# Town of Hilton Head Island Regular Design Review Board Meeting

Tuesday, December 11, 2012  
1:15 p.m. – Benjamin M. Racusin Council Chambers

PROJECT NAME: Sonesta Resort – ALTERATION & ADDITION

PROJECT NAME: The Westin – ALTERATION & ADDITION

**1 COVERED PORCH - FIREPLACE ELEVATION**  
ASK-06 1" = 1' - 0"

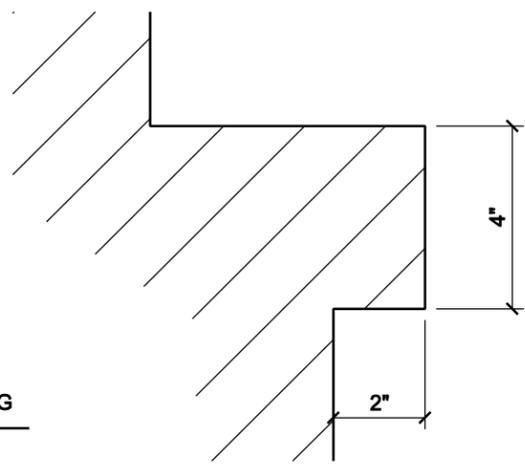
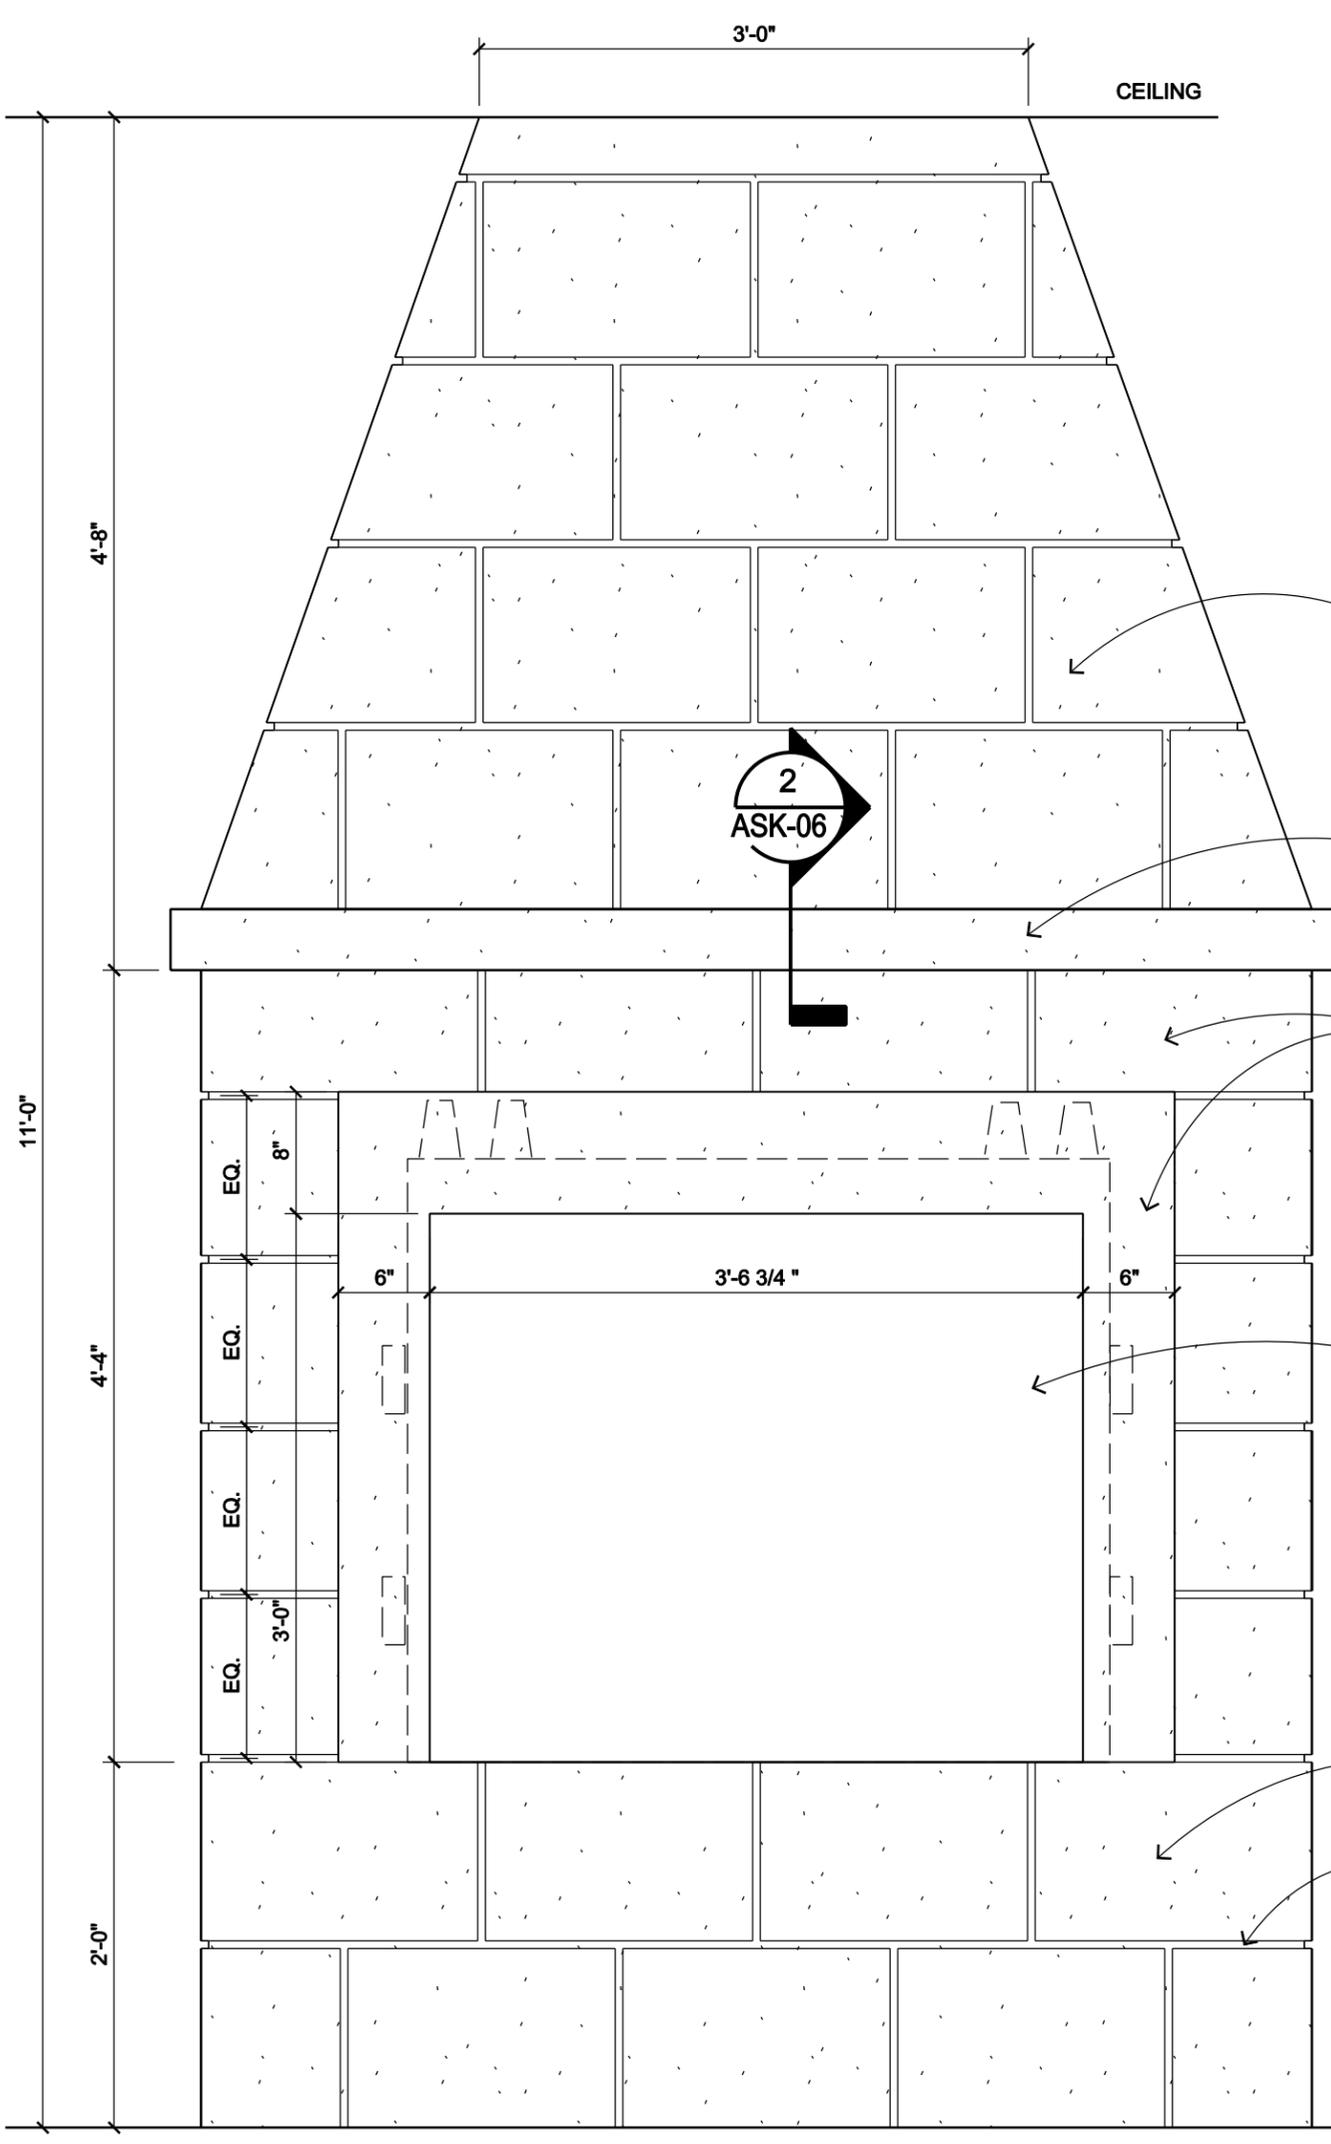
Based on previous DRB comments, the Applicant has modified the proposed fire place at the Sonesta Resort to be more in keeping with the design guide (smooth, fine sand stucco finish versus stone). Staff recommends approval of this application as submitted.

**THE WESTIN**  
HILTON HEAD ISLAND  
RESORT & SPA

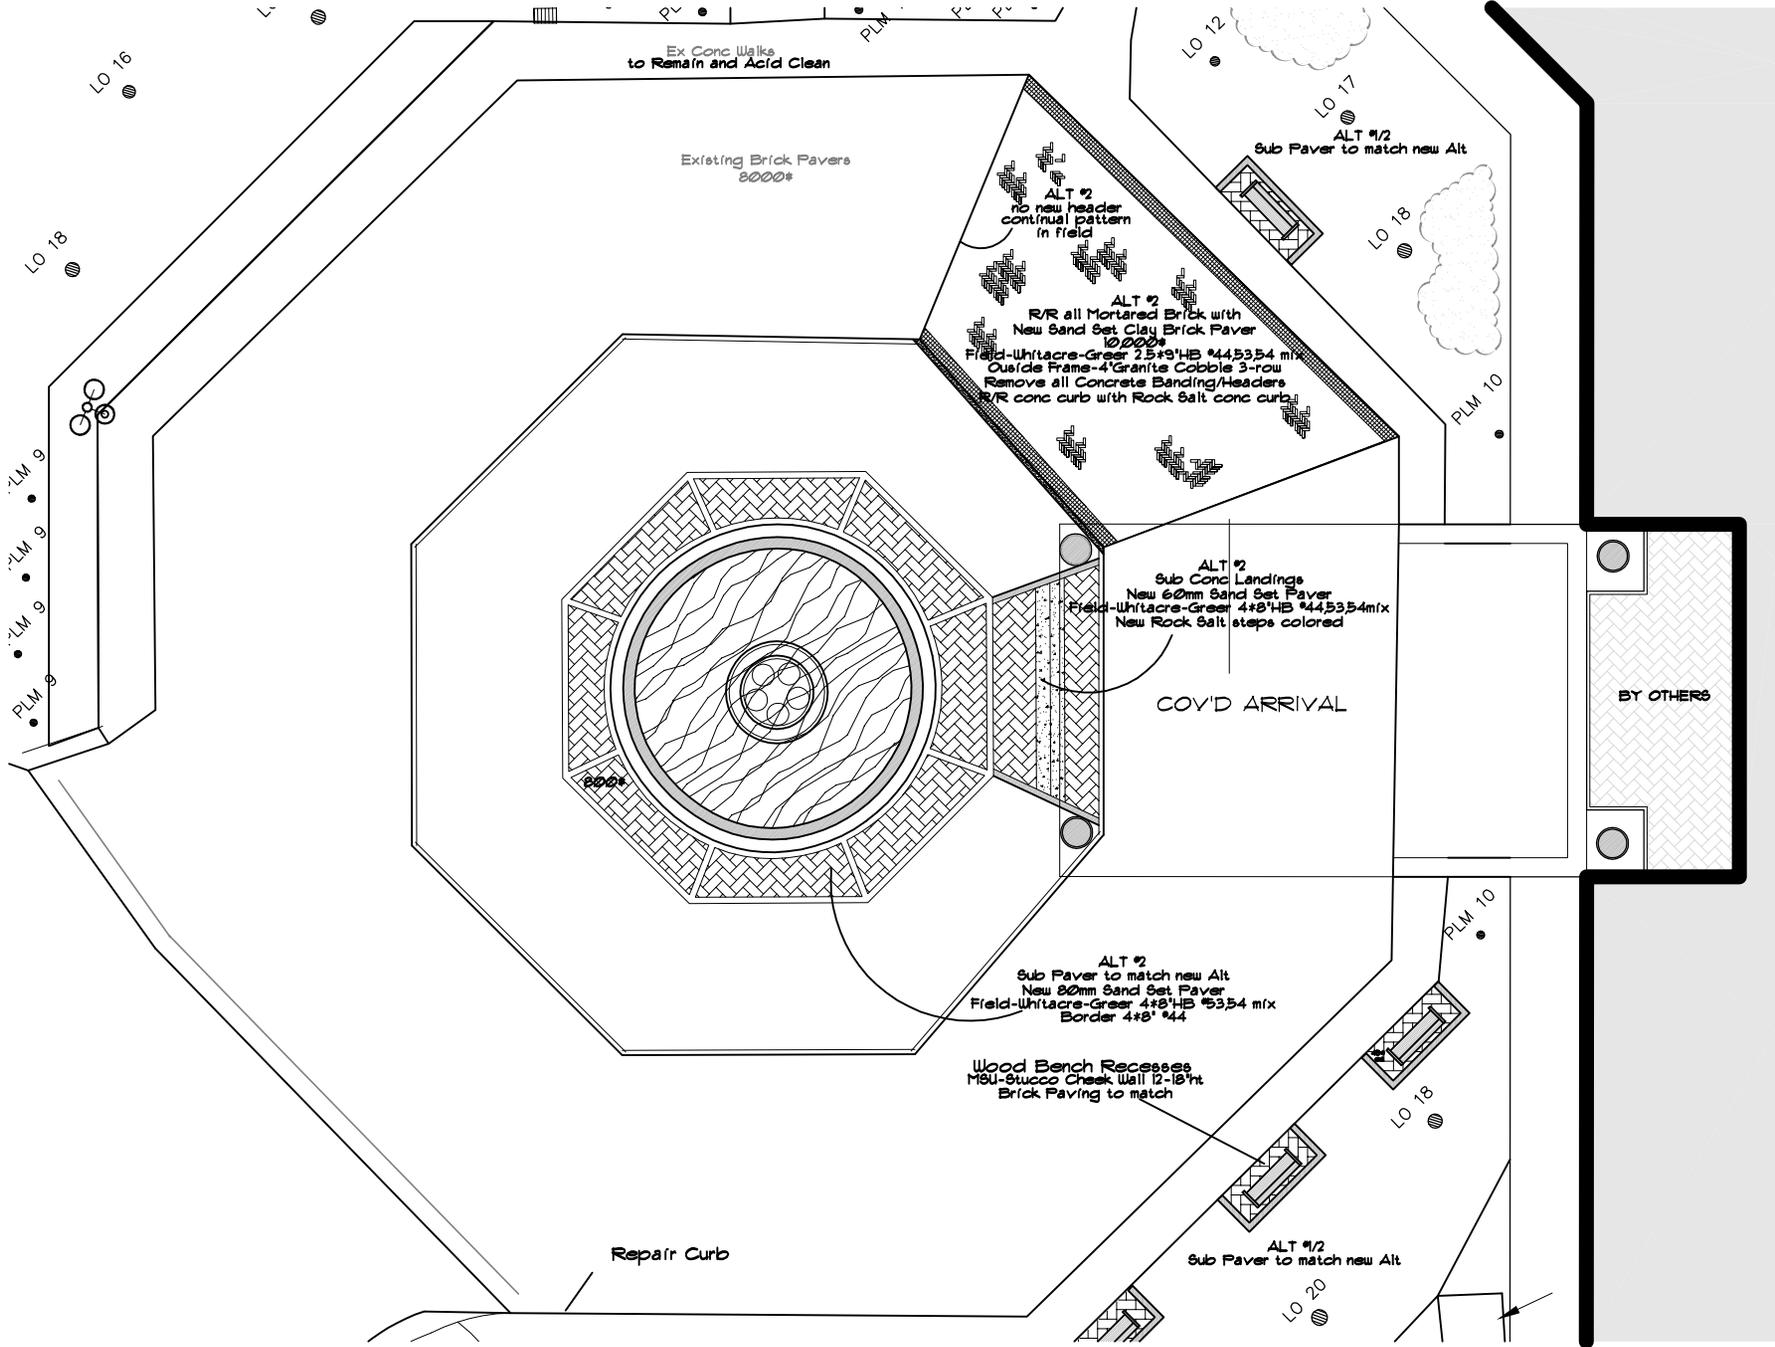
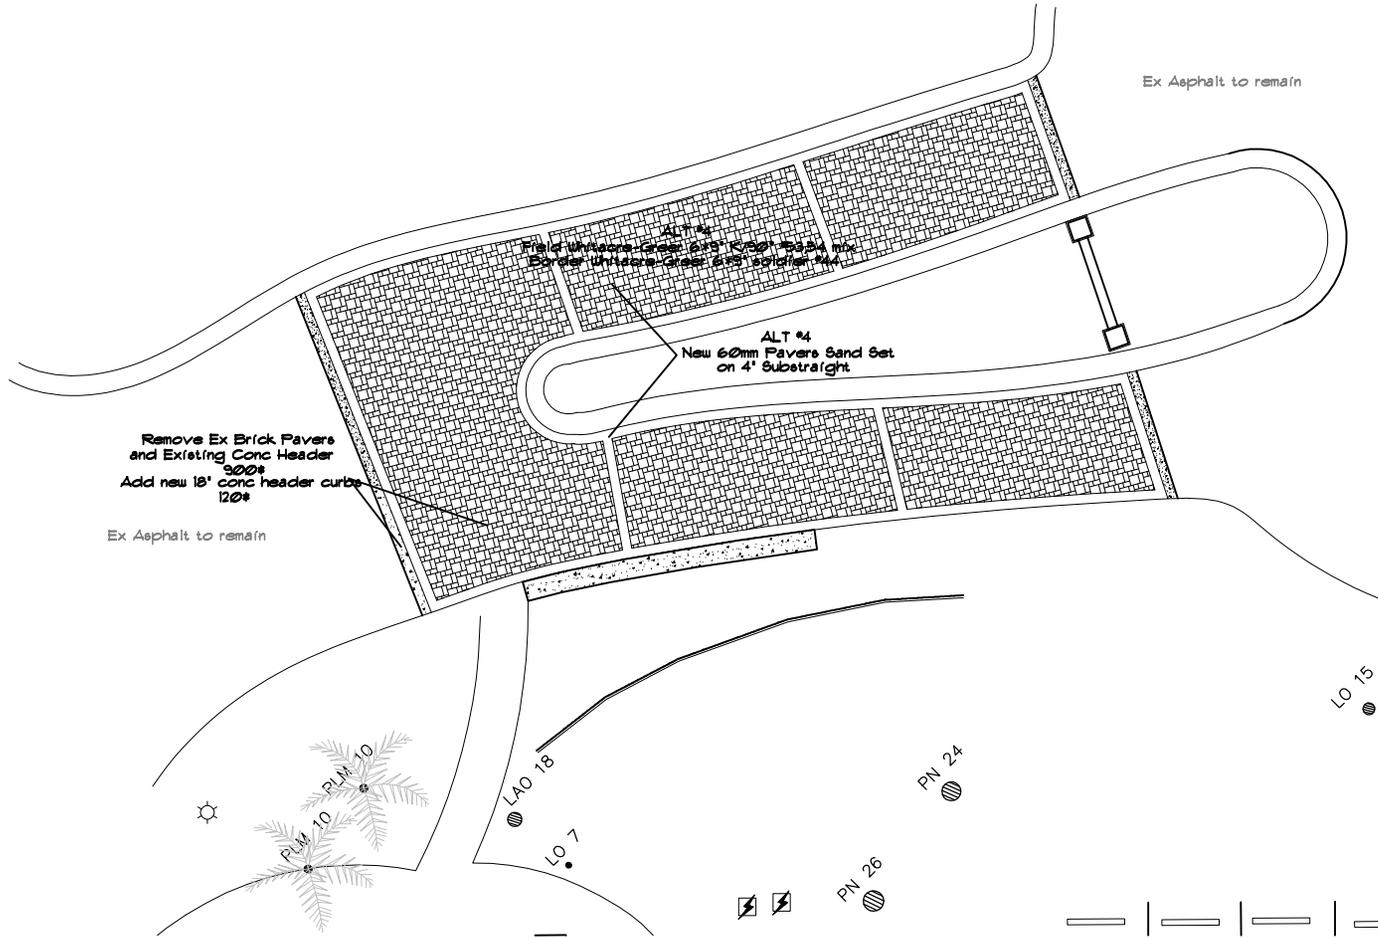
The Westin proposes to remove and replace the existing mortared brick pavers and existing concrete header curb at the entrance and to replace it with a field of Whitacre-Greer 6x9” pavers (mix of color 53 & 54) in a herringbone pattern with a border of Whitacre-Greer 6x9” pavers (color 44) in a soldier pattern with an 18” concrete header curb at each end. The applicant also proposes to replace the existing mortared brick pavers and existing concrete header curb/dividers with a field of Whitacre-Greer 2.5x9” pavers (mix of color 44, 53, & 54) in a herringbone pattern with an outside border of granite cobbles (3-row, grey) and no dividers.

Staff recommends approval of this application as submitted with the exception of the granite cobbles that should be replaced with a rock-salt concrete header curb and dividers to better complement existing and proposed materials and eliminate the introduction of another material.
